**LEVY COUNTY NUCLEAR POWER PLANT, UNITS 1 AND 2
DOCKET NOS. 52-029 AND 52-030
RESPONSE TO REQUEST FOR ADDITIONAL INFORMATION LETTER NO. 030 RELATED TO
STABILITY OF SUBSURFACE MATERIALS AND FOUNDATIONS**

**Levy Nuclear Power Plant Units 1 and 2
Response to NRC Request for Additional Information Letter No. 030 Related to
SRP Section 2.5.4 for the Combined License Application, dated May 8, 2009**

FIGURE RAI 02.05.04-20-1
FAILURE BLOCK FOR UPLIFT ANALYSIS

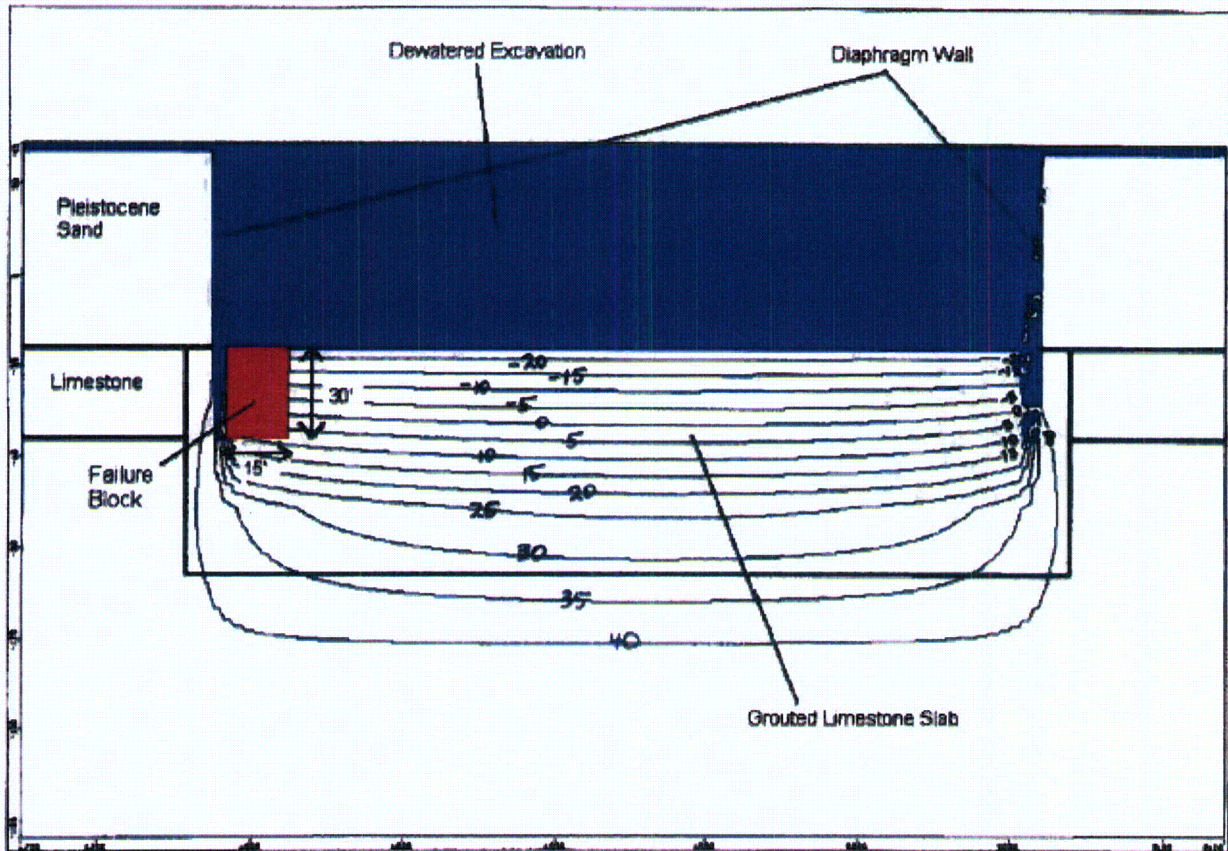
Please provide a sample calculation of your uplift analysis with figures showing assumptions.

The stability of the dewatered base was checked for local failure (by piping or boiling) and general failure of the rock below the excavation level (by heave or uplift). The local reduction of effective stress due to upward seepage was checked at the exit point where the minimum seepage path length existed.

A 15-foot wide block of heave zone was considered, adjoining to the diaphragm wall as shown below on Figure RAI 02.05.04-20-1. This width represents half of the diaphragm wall penetration depth of 30 feet.

F = (134-62.4) x 30 x 15 + 3456 x 30 = 135,900 lbs/ft

U = 30 x 15 x 1.13 x 62.4 = 31,730 lb/ft

FS = 135,900/31,730 = 4.3 > 1.5

FIGURE 3.5-2. Resultant Force and Overturning Moment for Elastic Solution Dynamic Soil Pressures
 FIGURE RAI 02.05.04-21-1
 DYNAMIC SOIL PRESSURE RESULTANT FORCE (ASCE 4-98)

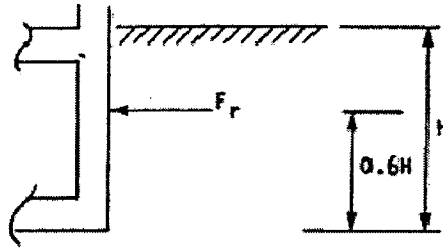
Please provide sample calculations of each. Please provide figures that aid in identifying parameters used in the equations.

Seismic at-rest pressure was calculated from the Woods method. The Mononobe-Okabe approach is not applicable since the diaphragm wall does not move sufficiently to mobilize the shear strength of the soil.

Seismic induced earth pressure was considered to be an inverse triangular shape, simplified from ASCE-98's parabolic shape. This simplified shape induced higher pressures at the upper portion of the wall and lower pressures at the lower portion of the wall. Thus, the wall exhibits the same dynamic thrust with a larger seismic-induced moment.

Poisson's ratio for the undifferentiated sediments was considered to be 0.3, conservatively estimated compared to existing soils, concrete fill, or reinforced concrete. Thus, from ASCE 4-98, C_v is 0.94 (see Figure RAI 02.05.04-21-1 below).
